**South West Yarragadee
Aquifer**
*Peer Review Panel Report on
South-West Aquifer
Modelling System
(SWAMS v 2.0)*

**South West Yarragadee
Aquifer**
*Peer Review Panel Report on
South-West Aquifer
Modelling System
(SWAMS v 2.0)*

October 2005

Figure 4.1 Pumping Tests in Yarragadee

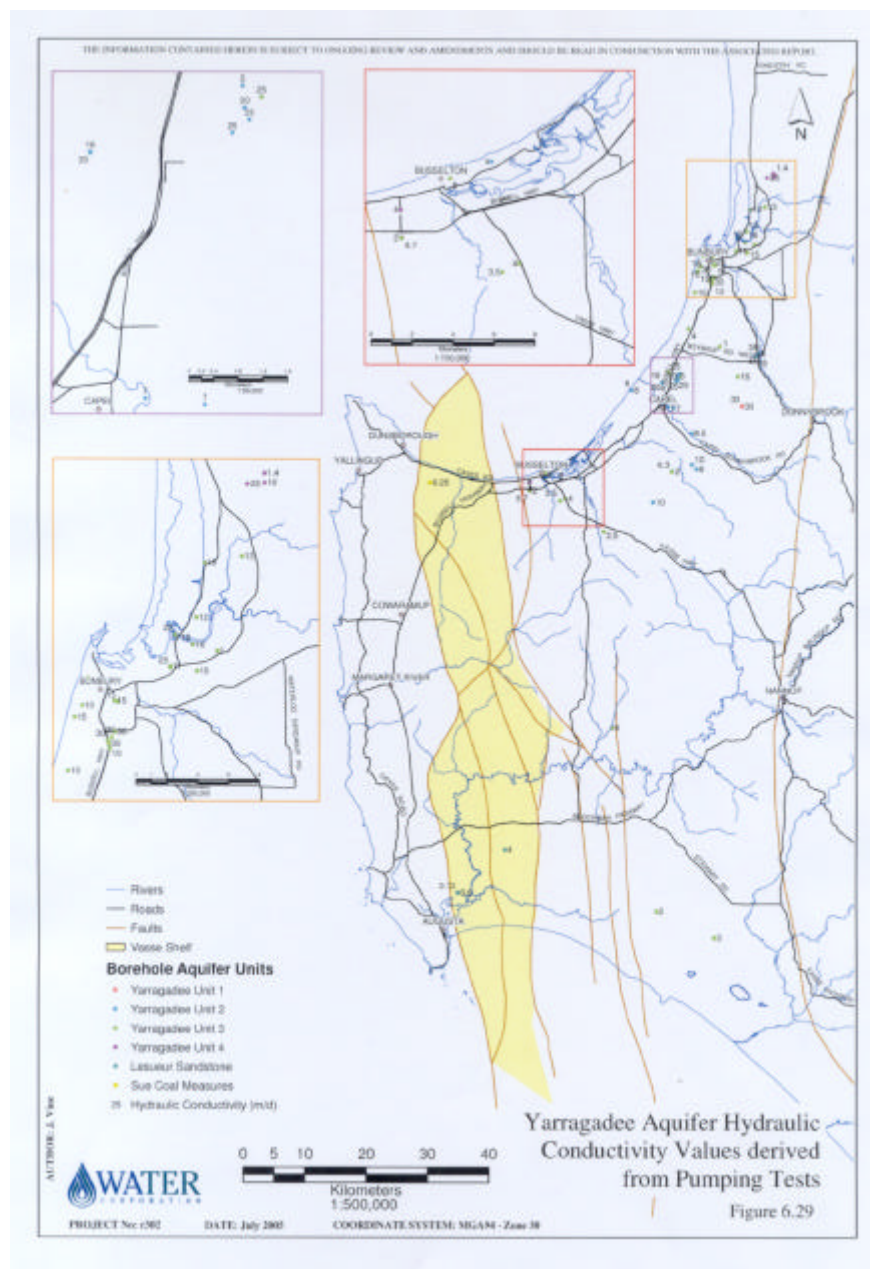
Water Corporation has provided pumping test values of hydraulic conductivities for private bores and parameter range (vertical and horizontal conductivity) have been provided for each parameter zonation for the model calibration. The Panel notes that

a total of 34 private bore pumping test data was evaluated for the Leederville aquifer and 63 from the Yarragadee aquifer (Figure 4.1). The majority of private bores in the Yarragadee aquifer are on the Swan Coastal Plain with a few on the Scott Coastal Plain. The test bore at Rosa Brook at the site of the proposed Western Borefield was tested at 10 ML/day for two weeks and drawdowns observed in a number of observation bores. The Panel has examined the pumping test data and notes that drawdowns were recorded from observation bores extending through the Yarragadee aquifer (with the exception of BP 16B, 2.5 km to the east) and into the lower third of the Leederville aquifer indicating a high vertical hydraulic conductivity. The Panel concludes that this confirms the potential for leakage not only from all units of the Yarragadee aquifer but also from the Leederville aquifer during large scale abstraction.

Figure 4.2 Comparison of Measured and Modelled Age Determinations for Yarragadee

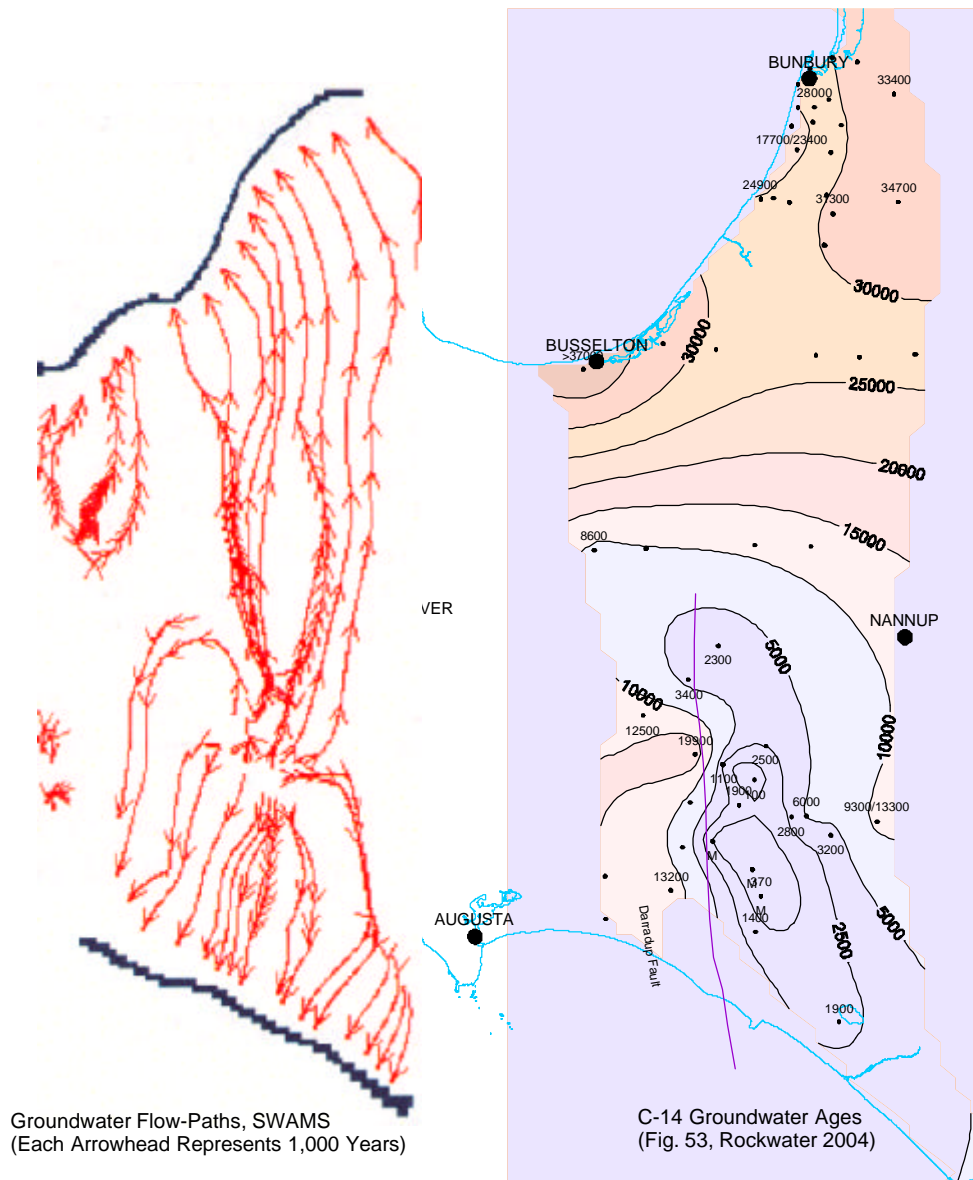
The Panel further notes that a series of carbon-14 age datings were measured for the Leederville (15 measurements) and Yarragadee aquifers (36 measurements) with groundwater ages in the deeper part of the Yarragadee aquifer in the northern part of the model exceeding 20,000 years. These age datings allow an evaluation of horizontal permeabilities within the aquifers by calculation of travel times based on hydraulic gradient and porosity. The Panel agrees that for the Yarragadee aquifer this equates to a regional hydraulic conductivity of 5.3 m/day between the recharge area (at monitoring bore KL 5) and the Dalyellup bore near Bunbury. Similarly software within SWAMS v 2.0 has been used to back-track Yarragadee aquifer flow lines from the Bunbury coastal discharge area to the Blackwood recharge area. The Panel compares the simulated flow paths against the carbon-14 age datings as presented in Figure 4.2 and conclude there is a reasonable agreement thereby giving credence to the hydraulic parameters adopted within SWAMS v 2.0.

Figure 4.3 Monitoring Bore Locations for Yarragadee

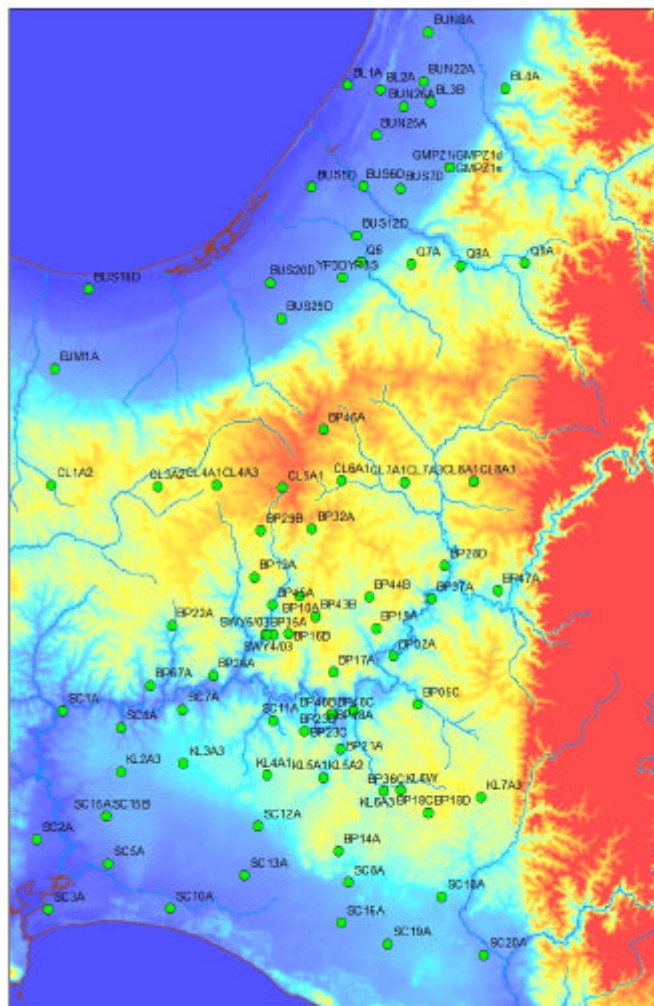
The Panel had indicated that some historical water level data was erroneous due to internal leakage within the observation bores and it was recommended that a hydrogeologist should review the available monitoring data and select representative sets of bores for each aquifer for model calibration.

This was undertaken. The Panel notes that a total of 328 observation bores were determined to be returning representative water level data suitable for inclusion in the model calibration (Figure 4.3). Of these 141 are in the Yarragadee aquifer and 100 from the Leederville aquifer. Nine bores from SWAMS v 1.2.1 were excluded from SWAMS v 2.0 by reason of false non-representative values (total of three) and several shallow bores (total of six) which went dry during model calibration. The Panel has in fact reviewed hydrographs for piezometers on the Karridale (KL) and Cowaramup (CL) Lines and noted several anomalies such as bores KL7W and CL8A3 suggesting that further review should be undertaken as it is considered that there are a number of additional monitor bores which could be excluded from the calibration process.

Figure 6.2 *Conceptual and Modelled Vertical Hydraulic Conductivities in Yarragadee*

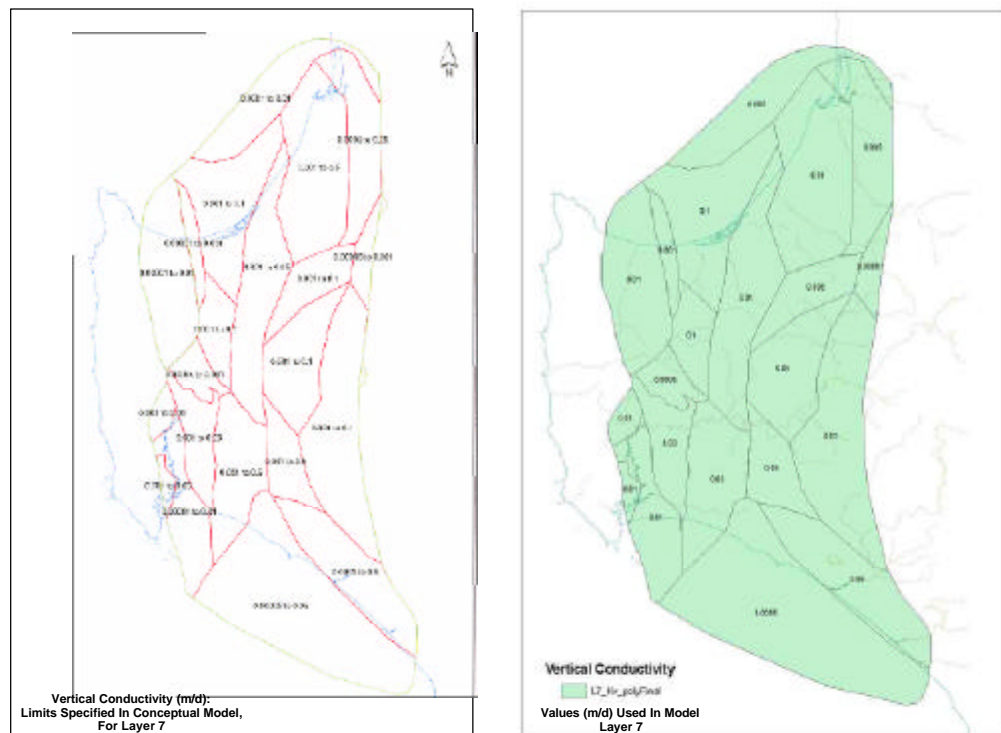
A value of hydraulic conductivity of 25 m/day adopted for Layer 1 on the Scott Coastal Plain around Lake Jasper seems to be too high in an area of mainly clayey sediments. Similarly, a value of 10 m/day for Layer 1 on the Swan Coastal Plain appears to be high for the Guildford Formation.

Ranges of horizontal hydraulic conductivity given in the conceptual model, and values adopted in the numerical model, are shown in *Figure 6.1*.

Figure 6.4 *Modelled vs. Observed Heads in Yarragadee*

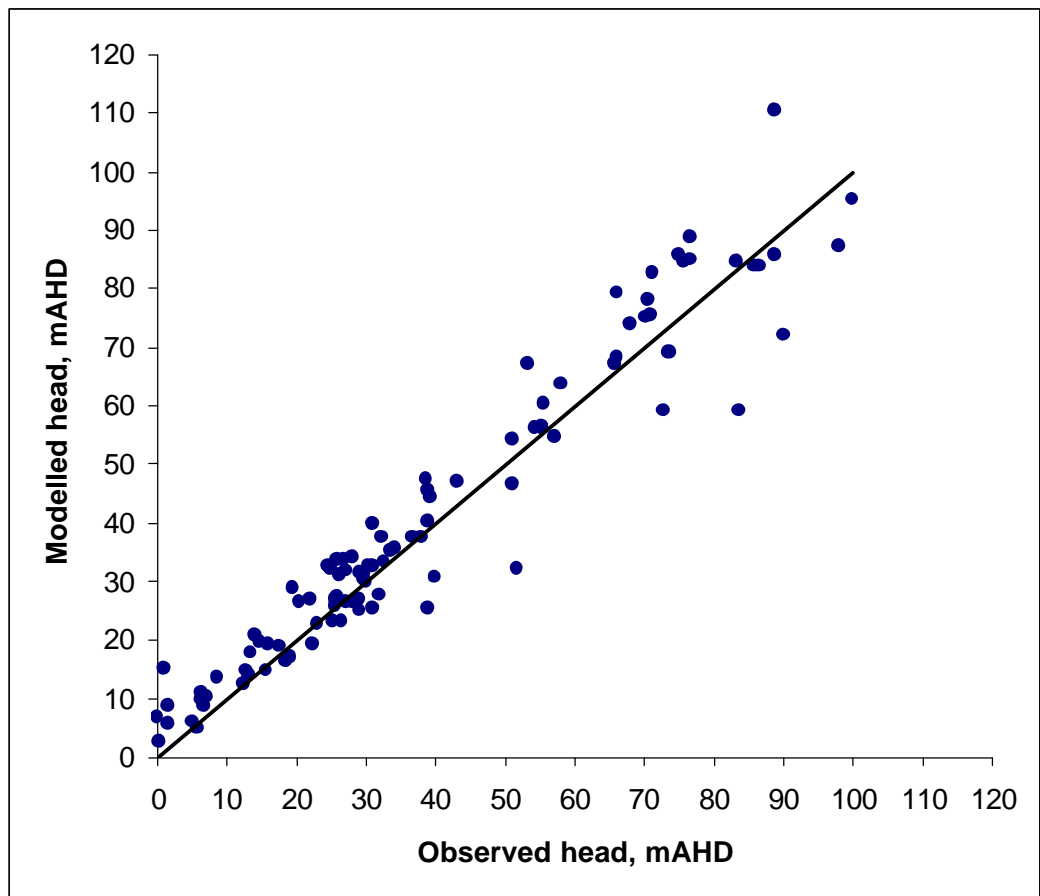
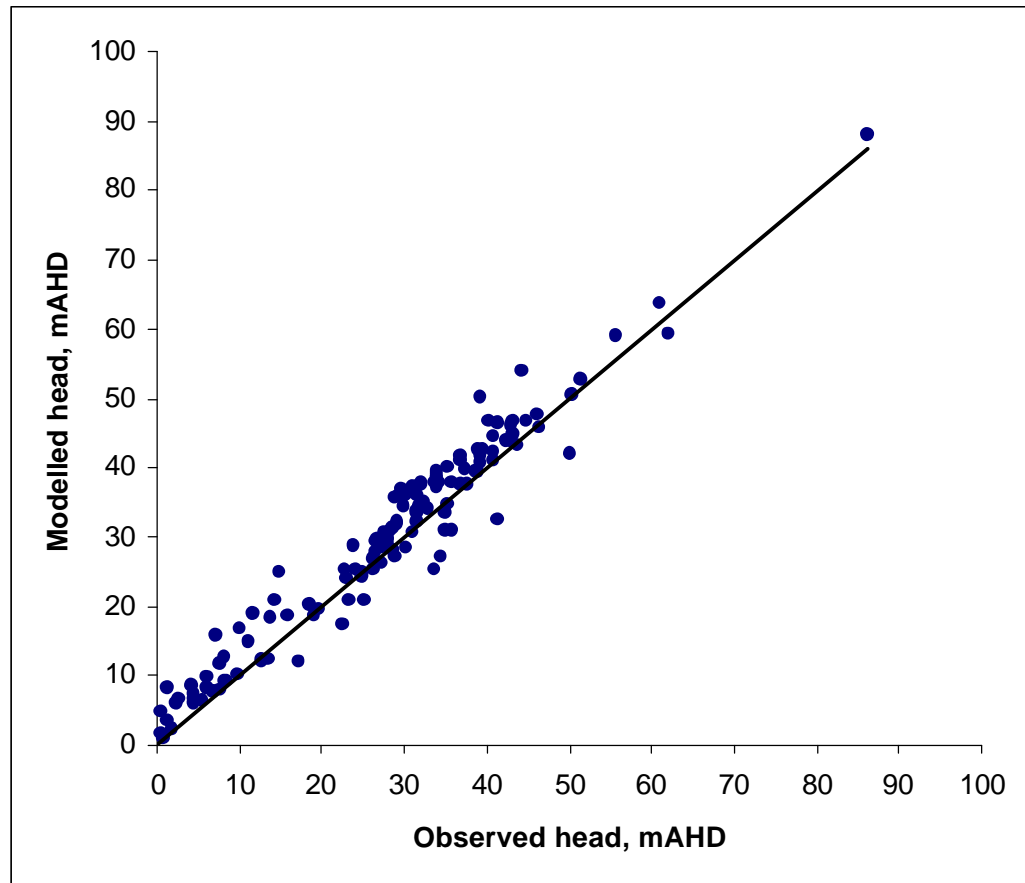
The plots of observed versus calculated heads show a wide scatter, particularly at high heads for the Leederville aquifer (*Figure 6.3*). Those for the Yarragadee aquifer are shown in *Figure 6.4*.

There has been marginal improvement in error statistics compared to the SWAMS version 1.2.1, particularly considering that monitoring bores with doubtful data are no longer used in the comparison:
